ENGINE - IGNITION - INTRODUCTION OF IMPROVED IGNITION LEAD, COOLING SHROUD AND THE
IGNITION COOLING BOX - CATEGORY CODE 5 - MOD.ENG-74-0002

V2500-ENG-74-0002

Powerplant - Ignition System - Introduction of Improved Ignition Cooling Box.

Installation of the improved Ignition Cooling Box and the improved Cooling Shroud for Exciter End (V2500-A1, -A5 and -D5)

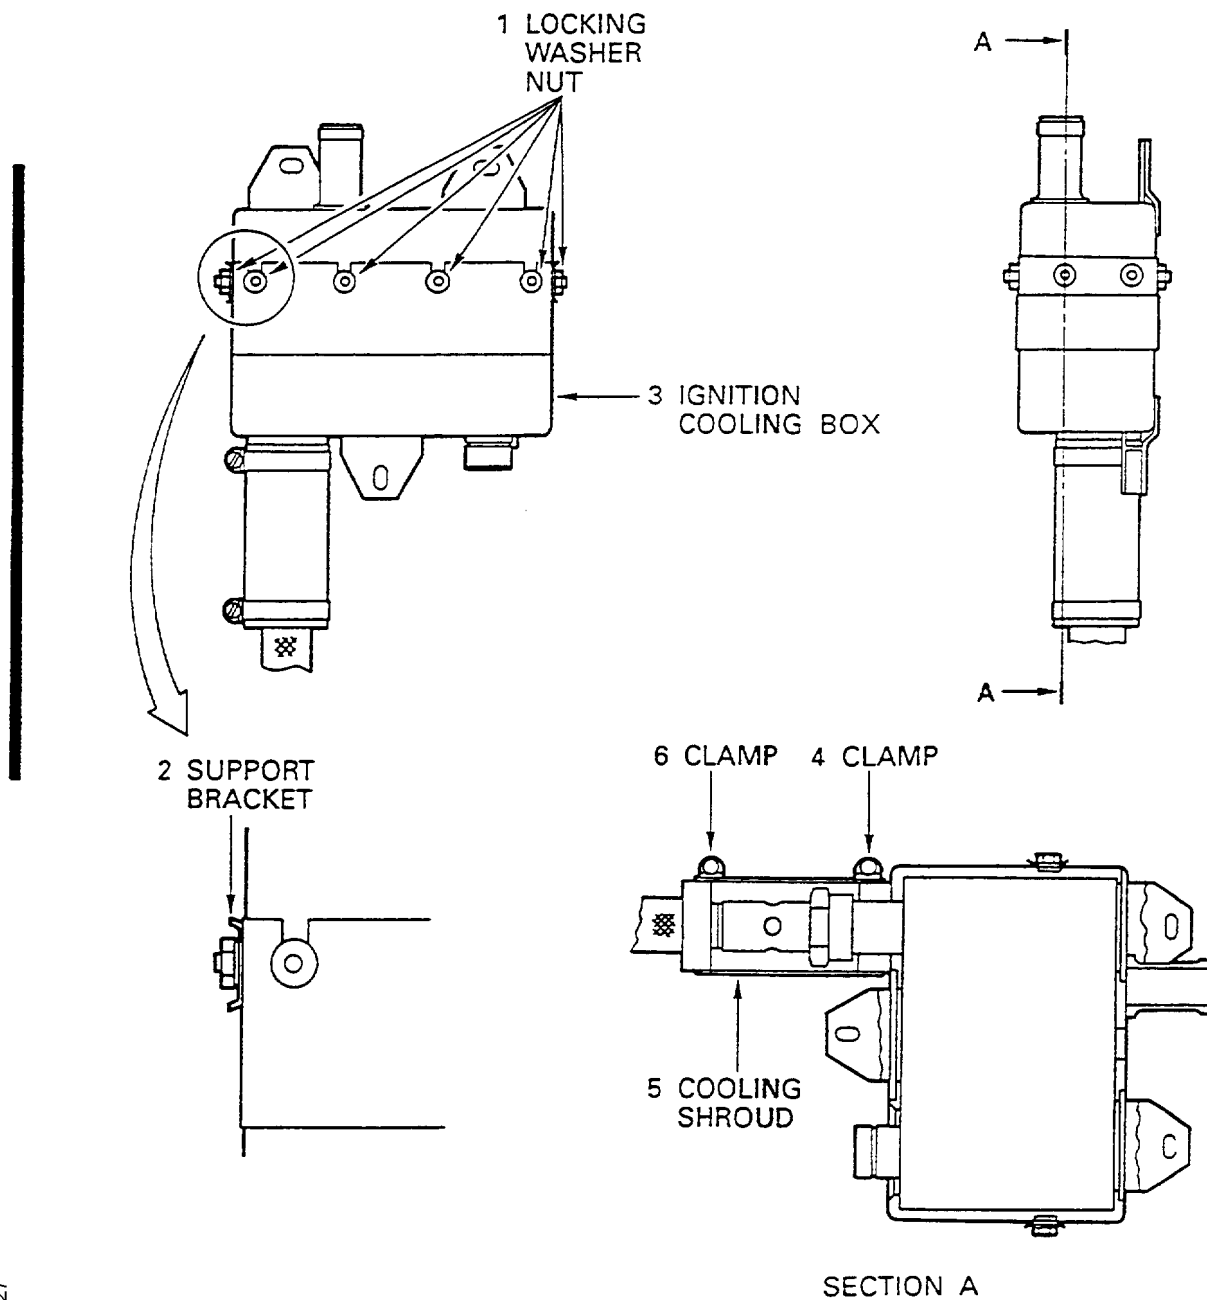
(a) Install the Ignition Cooling Box halves (See Figures 9 and 10)

1. Install the improved Cooling Box (3) (74-11-38, 01-100 and 01-102 or 01-500 and 01-502, PN 5U0058 and 5U0059 or 5U0066 and 5U0067) on the Ignition Exciter.

2. Install the Support Brackets (2) on to the side of Ignition Cooling Box (3).

3. Install the nuts (1).

4. TORQUE the twelve (12) nuts (1) to between 20 and 26 lbfin (2.26 and 2.94 Nm) (Refer to 1.K.(3)).

Before and after the modification of the Ignition Cooling Box and the Cooling Shroud for Exciter End (V2500-A1, A5 and -D5)

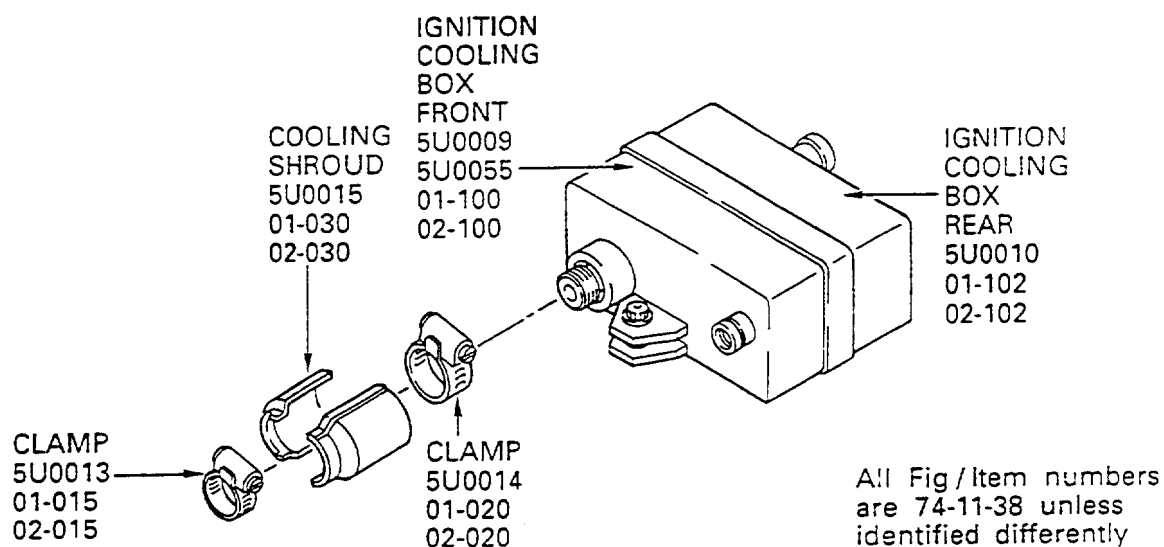
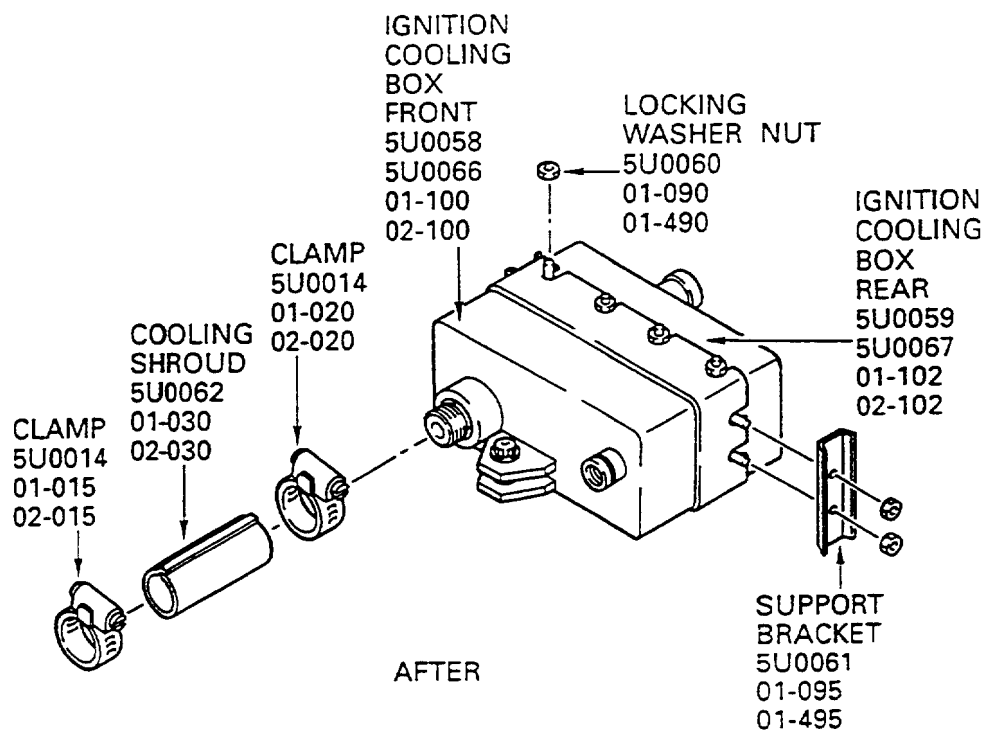
- (a) To apply modified spring/retainer and ferrule/adaptor assemblies in the Ignition Lead.
- (b) To add teflon gasket, studs and locking washer-nuts in the Front and Rear Cooling Boxes.
- (c) To introduce extended configuration of Cooling Shroud for Ignitor End with four stopper plates.
- (d) To apply one piece Cooling Shroud and support adapter at Exciter End.

- (6) Install the improved Cooling Shroud for Exciter End (See Figures 9 and 10)
- (a) Install the Cooling Shroud (5) onto the connection between the Ignition Exciter and the Ignition Lead.

- (b) Set the clamps (4) and (6) to the Cooling Shroud for Exciter End.
 - (c) TORQUE the clamp screws (4) and (6) to between 20 and 25 lbfin (2.26 and 2.82 Nm) (Refer to 1.K.(3)).

Cooling Box Assembly
Figure 2

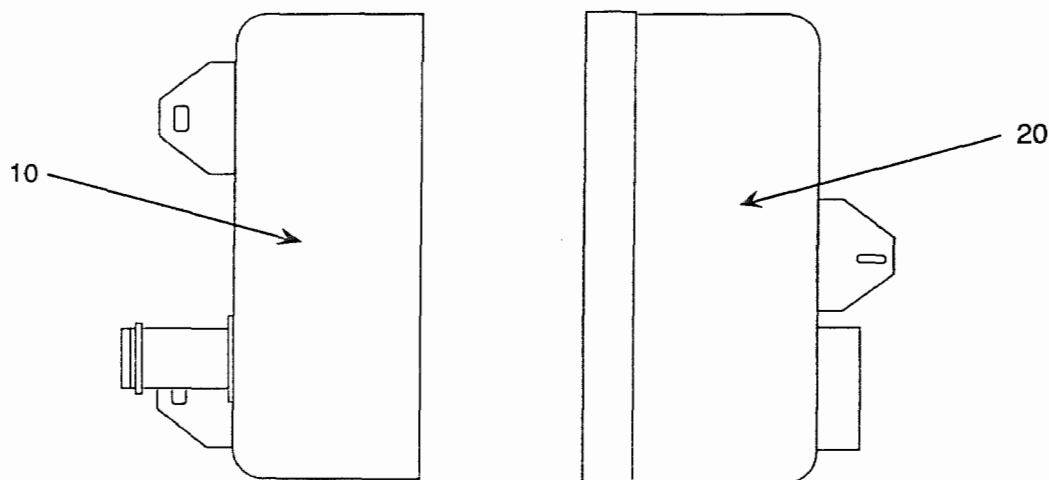
In some cases, installation tolerances affecting fit of the cooling box have resulted in assembly misalignment. The new front cooling box has a redesigned mounting pad which accommodates these tolerances to provide an improved fit.

This service bulletin is of a product improvement nature, and provides an exchange program through Unison's repair facility to exchange/upgrade existing P/N 9045428 Front Cooling Boxes to P/N 9054840.

B. Revise CMM 74-11-38 ILLUSTRATED PARTS LIST, page 1005, as follows:

FIGURE & ITEM NUMBER	PART NUMBER	AIRLINE PART NO.	NOMENCLATURE <u>1 2 3 4 5 6 7</u>	UNITS PER ASSY	USABLE ON CODE
2 -1	9045415-2		COOLING BOX Assembly	REF	A
-5	9045415-3		COOLING BOX Assembly	REF	B
10	9045429		. REAR COOLING Box	1	
-15	9045428		. FRONT COOLING Box	1	A
20	9054840		. FRONT COOLING Box	1	B
